WEST KETCHUM RESIDENCES DESIGN REVIEW
STAFF REPORT
KETCHUM PLANNING AND ZONING COMMISSION
REGULAR MEETING OF FEBRUARY 10, 2020

PROJECT: West Ketchum Residences

FILE NUMBER: P19-143

APPLICATION: Design Review

C1.0

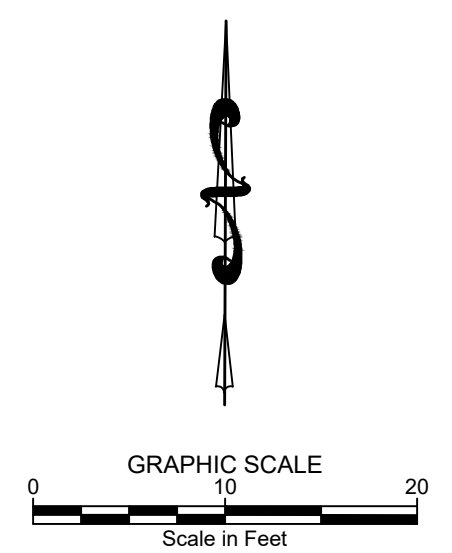
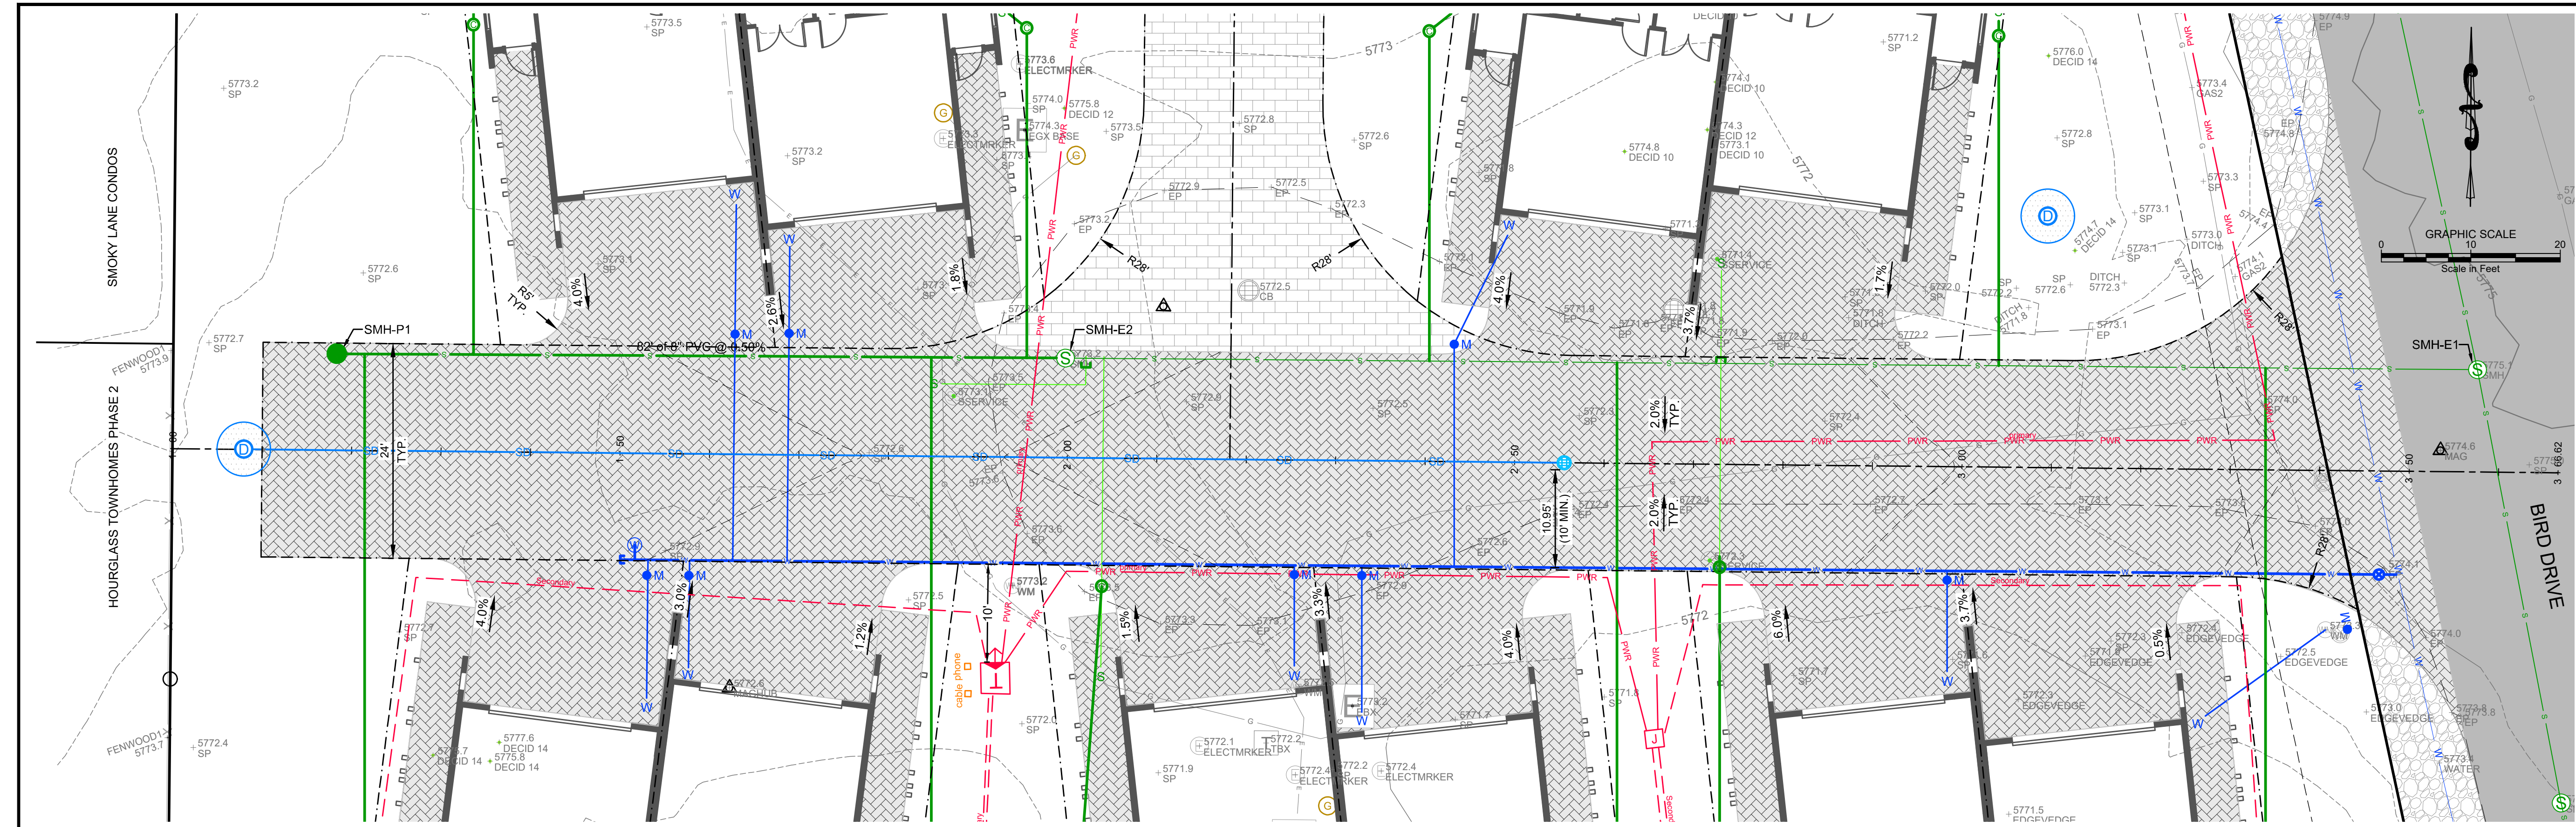
<i>Staff Comments</i>	<i>The drainage system must keep all storm water within the project site. The developer must install drainage improvements that meet City standards. Preliminary drainage plans are included on Sheets C1.0 and L1 of the project plans. The drainage plan includes a system of drywells and catch basins. Preliminary details for the drainage improvements are included on Sheet C2.0.</i> <i>Prior to issuance of a Building Permit for the project, the applicant shall submit a final drainage plan indicating grading, catch basins, piping, and drywells (KMC §17.96.040.C.2b & KMC §17.96.060.C.1-4) prepared by a civil engineer licensed in the state to be submitted for review and approval by the City Engineer and Streets Department. See Table 2 for City Department comments including City Engineer and Streets Department conditions.</i>
<input checked="" type="checkbox"/>	<input type="checkbox"/>	<input type="checkbox"/>	17.96.060.C2 Drainage	Drainage improvements constructed shall be equal to the length of the subject property lines adjacent to any public street or private street.
